INDESIT company

Model type:
LV62IX

Commercial code:
F026565

## n1045034: New top condenser.

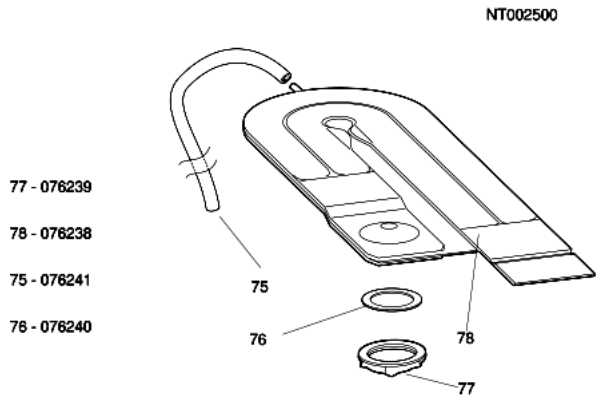
As of the last week in July 2000, the new "Wind drying system" was inserted on some appliances from the new MarckII Range.
This new system foresees the elimination of the lateral air-flow body and the insertion of a new system with top condenser.
The spare part numbers eliminated are as follows:

054927(Rohs 144335) - RING NUT FOR AIR-FLOW BODY
054928 - AIR-FLOW BODY
103689 - NOZZLE GASKET

057874 - TOP SOUNDPROOFING LAYER

Whereas the new spare part numbers are:

076238 - WIND DRYNG SYSTEM CONDENSER
076239 - CONDENSER RING NUT
076240 - TOP CONDENSER GASKET
076241 - TOP CONDENSER PIPE

The new part numbers are not interchangeable with the old ones, as they are completely different. See technical drawing attached to notice NT002500.

NT008000

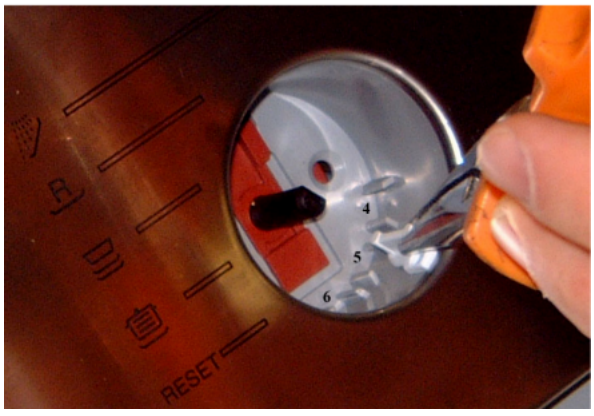
On dishwashers concerned with the current notice to adapt the commutator 8 positions on appliances with 4, 5 or 6 wash cycles, the plug for the final cycle will be employed for the programmes handle Code Sat. 087976.
The mentioned particular will be inserted according to the appliance's cycles assisted on the appropriate slot.
See diagram NT008000.

## n1045056: MARK II LOWER TANK SEAL

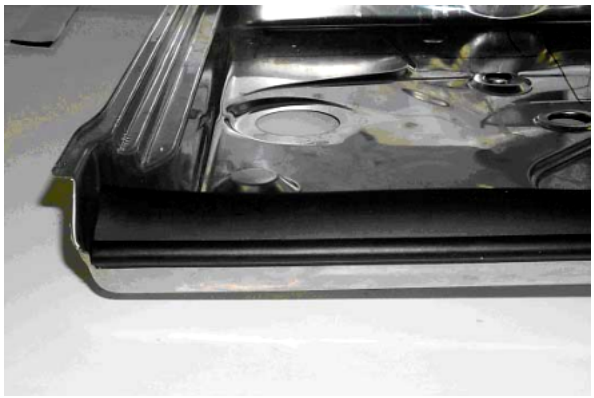
In order to resolve the problem of water leaking from the bottom of the door, all dishwasher models affected by this modification, from serial number 20420.0001 on, have been equipped with lower tank seal, sat code 088505.
See figure "N1045056"

## n1045062: Introduction of a new DW EVO structure

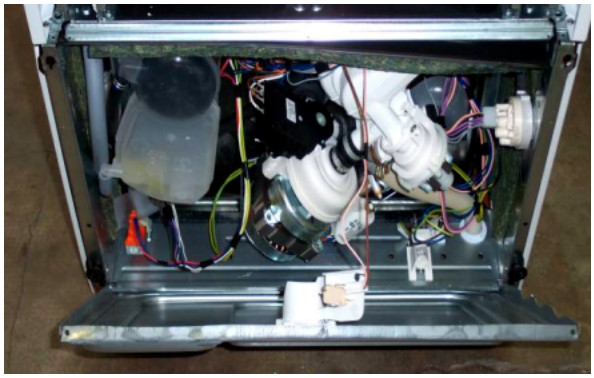
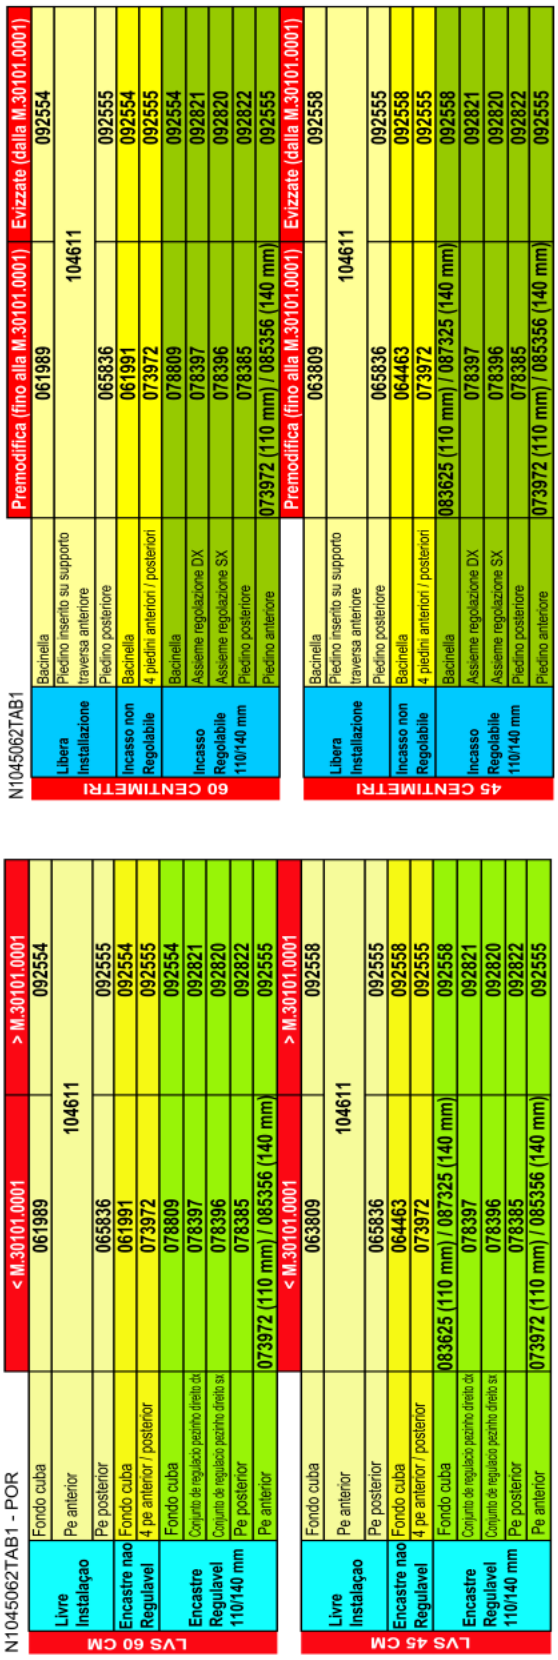
From serial number 30101.0001, all dishwasher models affected by this modification have been produced with EVO structure. These models have been equipped with NEW TRAYS AND NEW FEET (see N1045062TAB1).

Photo N1045062FIG1 illustrates the bottom of the dishwasher with EVO structure.

Regulation assembly DX/SX Sat codes 078397 and 078396 will be managed up to stock end, after that they will be replaced by

new Sat codes 092821 and092820. The same is for rear foot Sat code 078385 which will be replaced by Sat code 092822.

N1045063

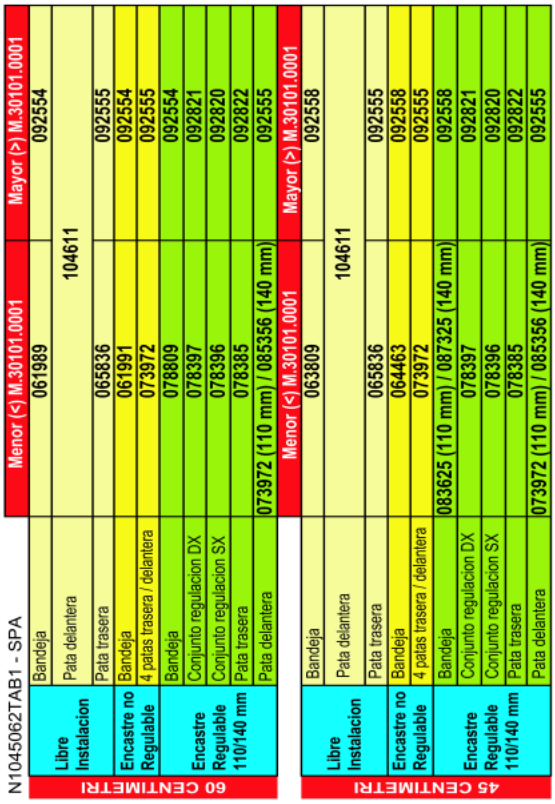
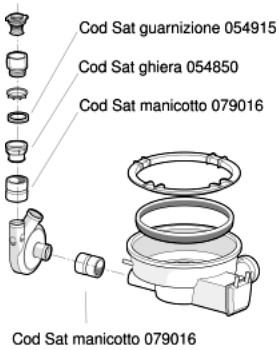
From serial number 30224.0001, all dishwashers affected by this modification have been equipped with the new coupling+ring nut assembly Sat code 093752, in place of coupling Sat code 079016, ring nut Sat code 054850 and gasket Sat code 054915.

Ring nut Sat code 054850 will continue to be available from the spare parts warehouse while stocks last, and coupling Sat code 079016 will continue to be stocked because it is still used for the tank-volute connection.
Picture N1045063 illustrates the premodification structure in FIG1 and the new structure in FIG2.

## n1045086: Modification of locking units and inside doors on 60 cm dishwashers

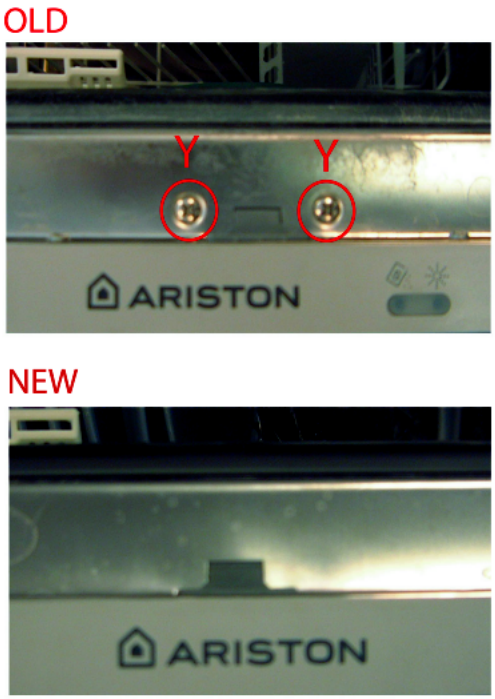
From serial no. 40614.0001, all 60 cm dishwashers affected by this note have been equipped with the locking unit code 094128 in place of 085357.
Following the elimination of the two screws Y (see N1045081FIG1) used to fix the locking unit on the inside door, the locking

unit and inside door were also modified, which can be mounted on premodification appliances by replacing the premodification locking unit with the new one.

Codes of modified inside doors:
085023 PREMODIFICATION - 112451 NEW
